## **Rezoning Transportation Analysis**

Petition Number: #2022-126

General Location Identifier: 05108127

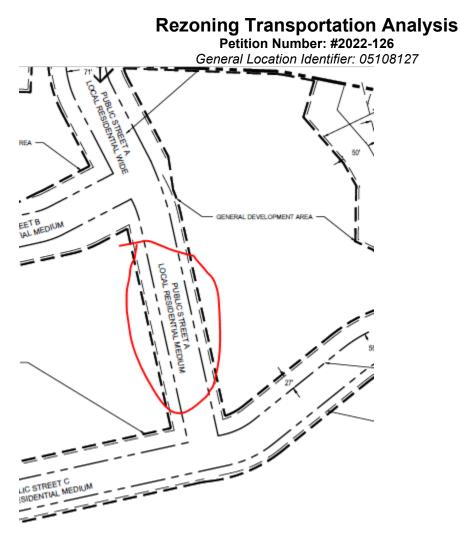
- 6. Revise conditional note specifying "All transportation improvements will be approved and constructed before the site's first building certificate of occupancy is issued. The petitioner may phase transportation improvements if said improvements and phasing are explicitly described in site plan notes."
  - 5. UNLESS STATED OTHERWISE HEREIN, THE PETITIONER SHALL ENSURE THAT ALL TRANSPORTATION IMPROVEMENTS ARE SUBSTANTIALLY COMPLETED PRIOR TO THE ISSUANCE OF THE SITE'S FIFTIETH (50<sup>TH</sup>) BUILDING CERTIFICATE OF OCCUPANCY.

Clarifying comment from 1/24/2023: Revise conditional note to all transportation improvements will be approved and constructed before the site's first building certificate of occupancy. Instead of the 50<sup>th</sup> building CO as shown in the image above.
